Riverview Condominiums

Punching Shear Review

Thornton Tomasetti

February 14, 2025

Figure 3: Visually identifiable slab cracks around a column along Grid Line B. At least two core holes are potentially positioned along the critical slab section for punching shear.

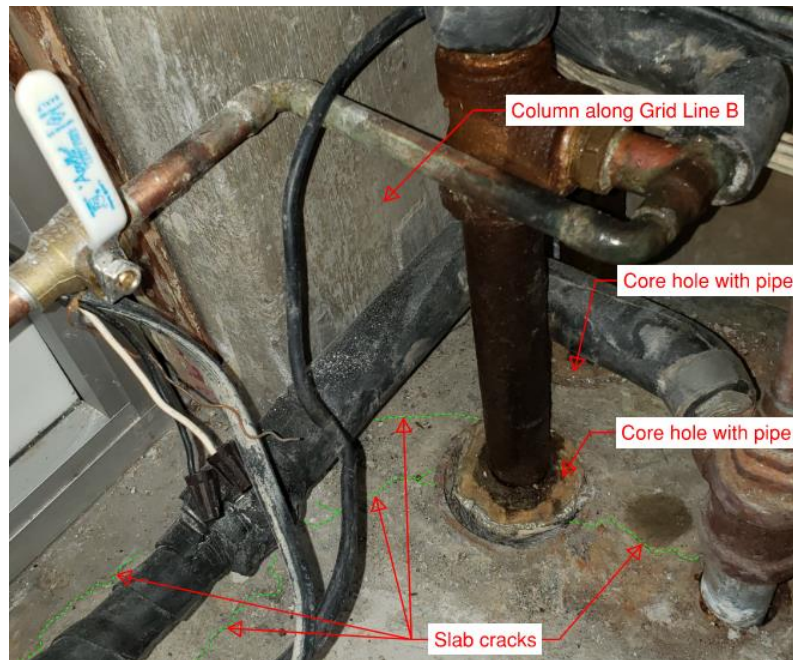
TT performed a second site visit on June 26, 2024 with SGH to view exposed floor slab areas on multiple levels as part of their limited exploratory program. We observed slab cracks in the vicinity of several columns along Grid Lines B and E (Figure 3). Various core holes are located around the columns along Grid

Lines B and E. TT did not observe exposed slab-to-column connections along Grid Lines C and D. We observed evidence of concrete spalls and rebar corrosion at the floor slabs along Grid Line E (Figure 4).

Figure 5: Critical slab section for punching shear at slab-to-column connection.

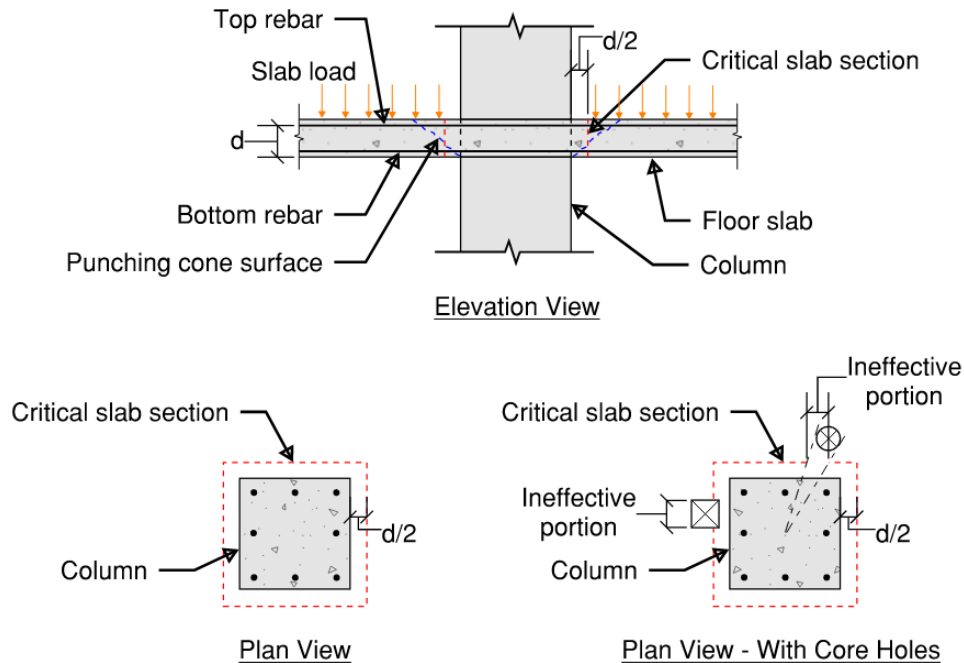
Top rebar placed lower in the slab at slab-to-column connections reduces the rebar depth d and therefore decreases the critical slab section. This in turn increases the shear stresses at the critical section. If the top rebar is placed too low, then the shear stresses at the critical slab section will exceed the slab shear strength and cause punching shear failure (DCR exceeds 1.0, or, for existing structures, DCR exceeds 1.05). TT considered the as-built top rebar depths at the slab-to-column connections from SGH's GPR scanning. We conservatively considered the minimum top rebar depth in calculating the punching shear strength at locations where multiple top rebar depths were measured.

The presence of core holes positioned along the critical section is another factor that decreases the critical slab section, as depicted in Figure 5. TT did not consider the influence of reduced critical sections from core holes on punching shear capacity due to the unique conditions at each slab-to-column connection.

Figure 2. Typical section of 7th Floor slab indicating as-built conditions.

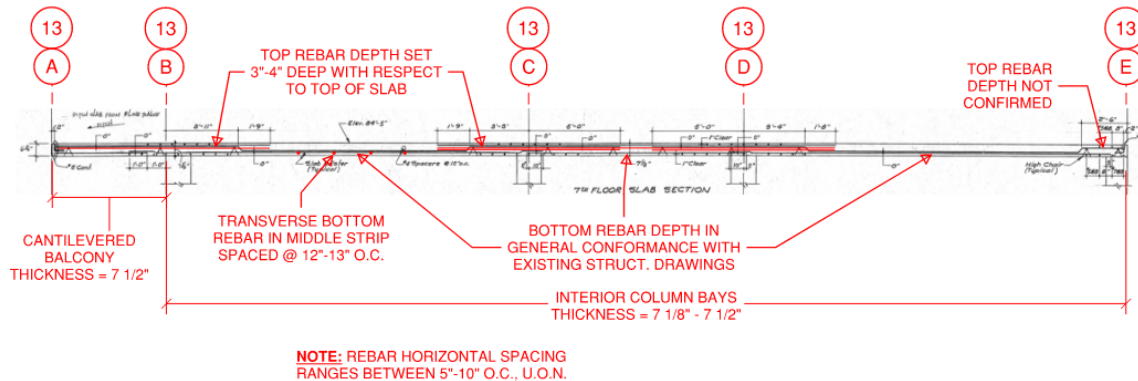
We identified several areas where the as-built top rebar depths are set lower than specified in the existing structural drawings. The existing drawings specify slab rebar to have 1" minimum protective cover. This implies that the top rebar should be nominally set at a depth of 1" plus half the rebar diameter with respect to the top of slab. Based on our scan data, the as-built top rebar depths are set much lower, between 3"-4" deep. The placement of the top rebar is essential for the slab strength at negative bending moment regions in the vicinity of columns. The depth of the top rebar also effects the slab punching shear strength at the columns. Top rebar that is set lower in the slab generally reduces both the slab negative flexural strength and the punching shear strength.

Our scans show that the bottom rebar depths are set between 5 ½" – 6 ¼" deep with respect to the top of slab. The existing structural drawings imply that the bottom rebar should be nominally set at a depth of 1" plus half the rebar diameter with respect to the bottom of slab. The as-built bottom rebar depths would be generally acceptable for the bottom rebar placement. The placement of the bottom rebar is important for the slab strength at positive bending moment regions between columns.

The as-built slab conditions are summarized in Figure 2 for a typical section of the 7th Floor slab.

Figure 3. Moment diagram of column strip along Grid Line 13 at 7th Floor showing locations with inadequate negative flexural strength.

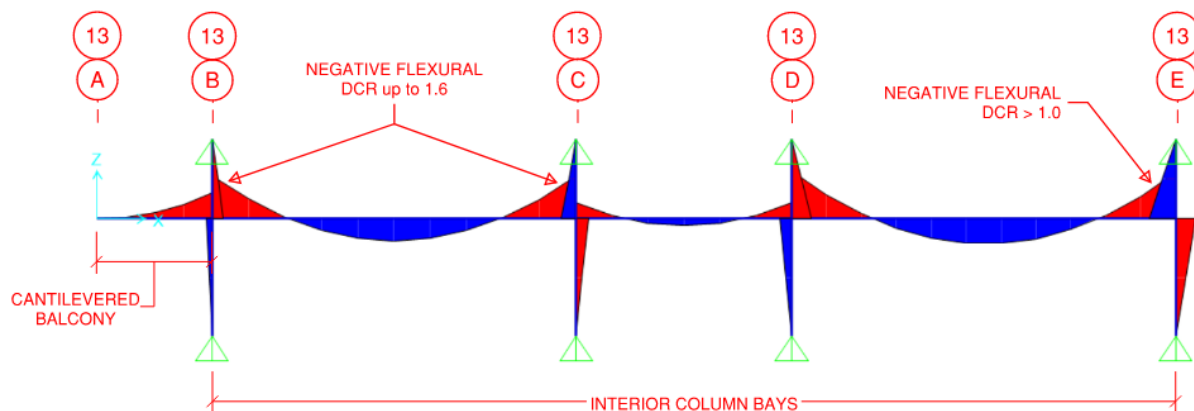
The elastic strip methods determined that the slab has inadequate negative flexural strength at three locations along the representative column strip when considering the as-built slab conditions (Figure 3). Of note, the cantilevered balcony slab has sufficient negative flexural strength where the slab joins the south column line along Grid Line B.

Figure 4. Part plan view of representative area of 7th Floor slab indicating slab-to-column connections with inadequate punching shear strength for as-designed condition (highlighted in red). All slab-to-column connections fail in punching shear for the as-built condition.

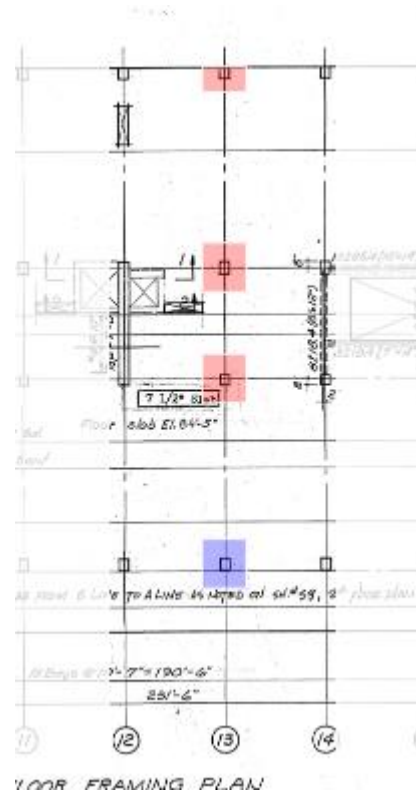
TT evaluated the punching shear DCRs using CSI SAFE for both the as-designed condition according to the existing structural drawings and the as-built condition. Figure 4 indicates the slab-to-column connections having inadequate punching shear strength for the as-designed

condition. All slab-to-column connections were found to have insufficient punching shear strength for the as-built condition.

Photo 7: Typical slab-to-column connection exhibiting core holes and cracks around a column.

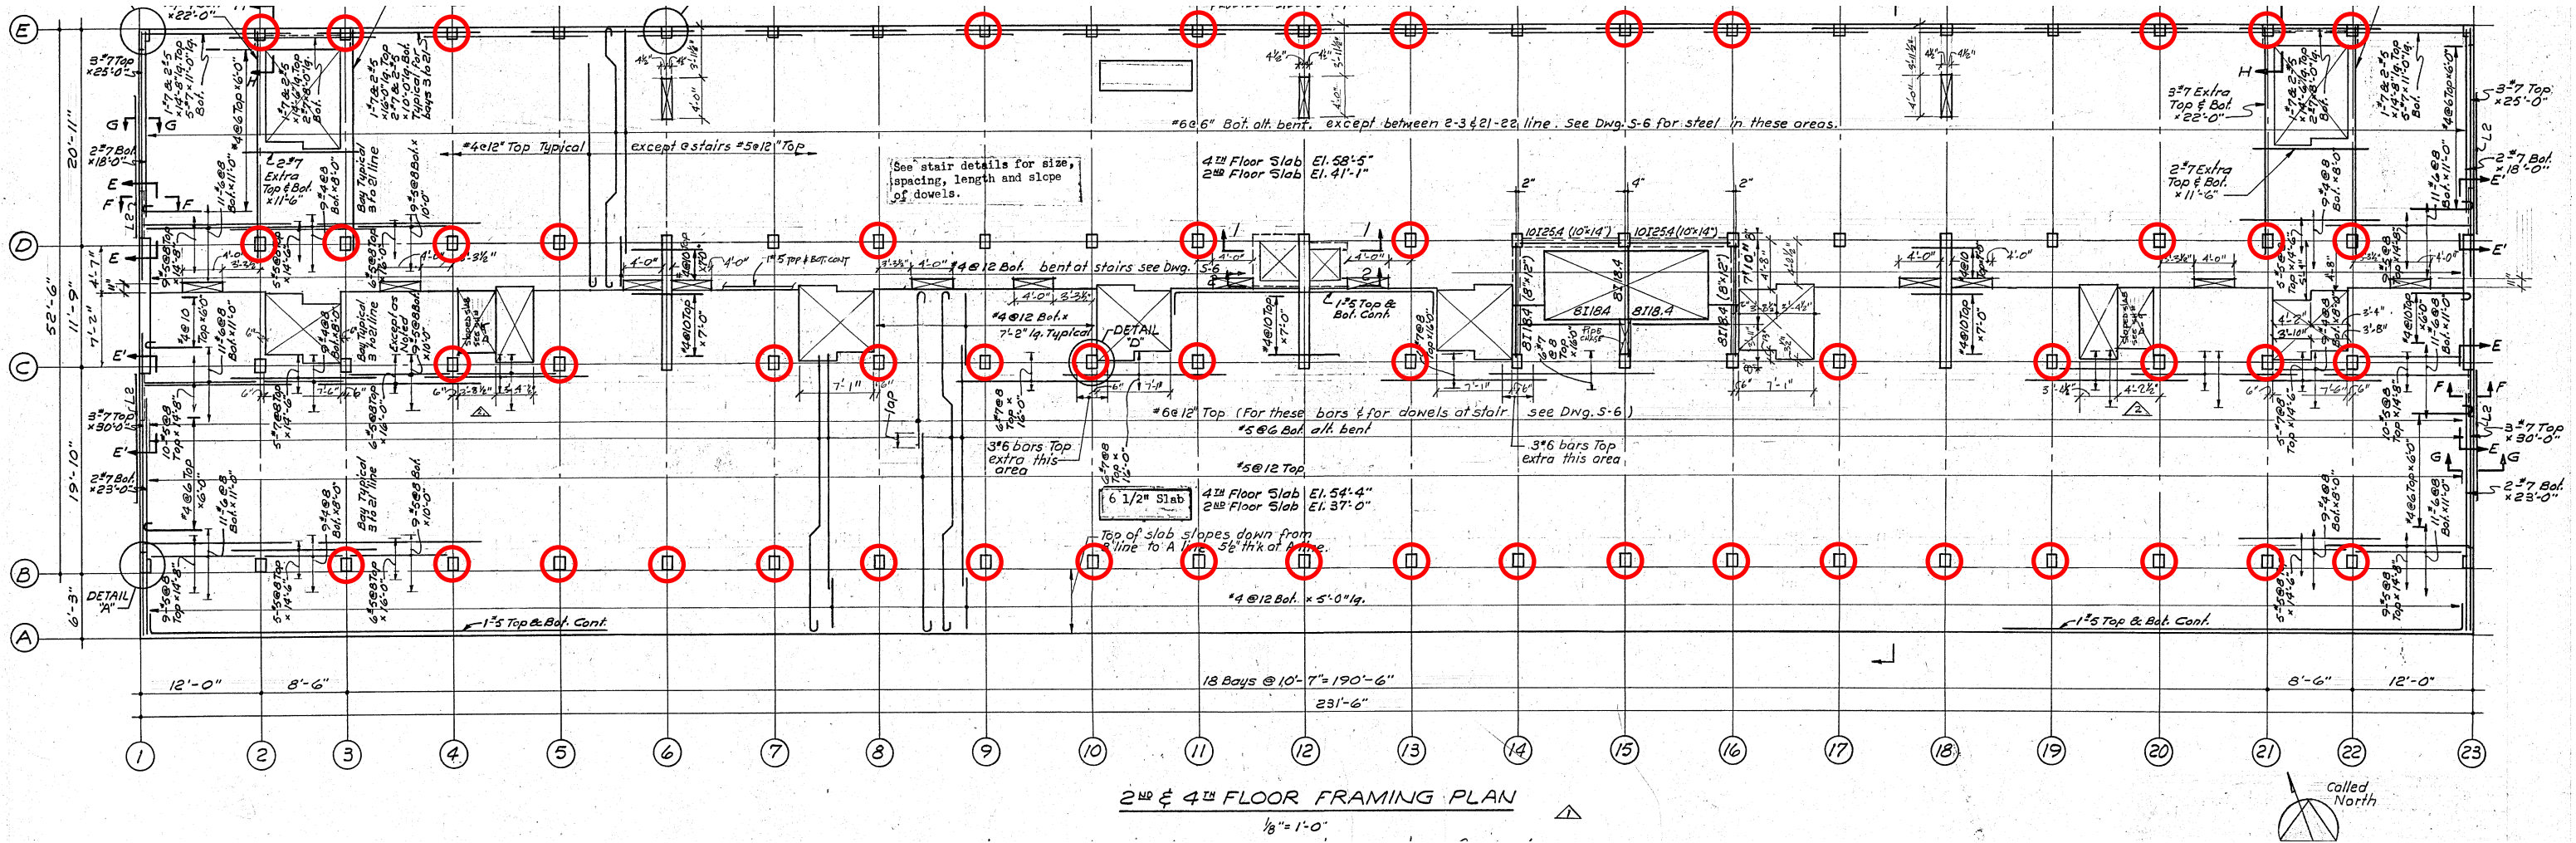
Photo 8: Slab-to-column connection exhibiting three core holes clustered together directly adjacent to the column face.

The floor slab punching shear capacity could be permanently increased by post-installing steel collars to the required columns to increase the critical slab sections around the columns. Alternatively, new reinforced concrete drop panels could be formed and poured at the required columns to increase the critical slab sections around the columns.
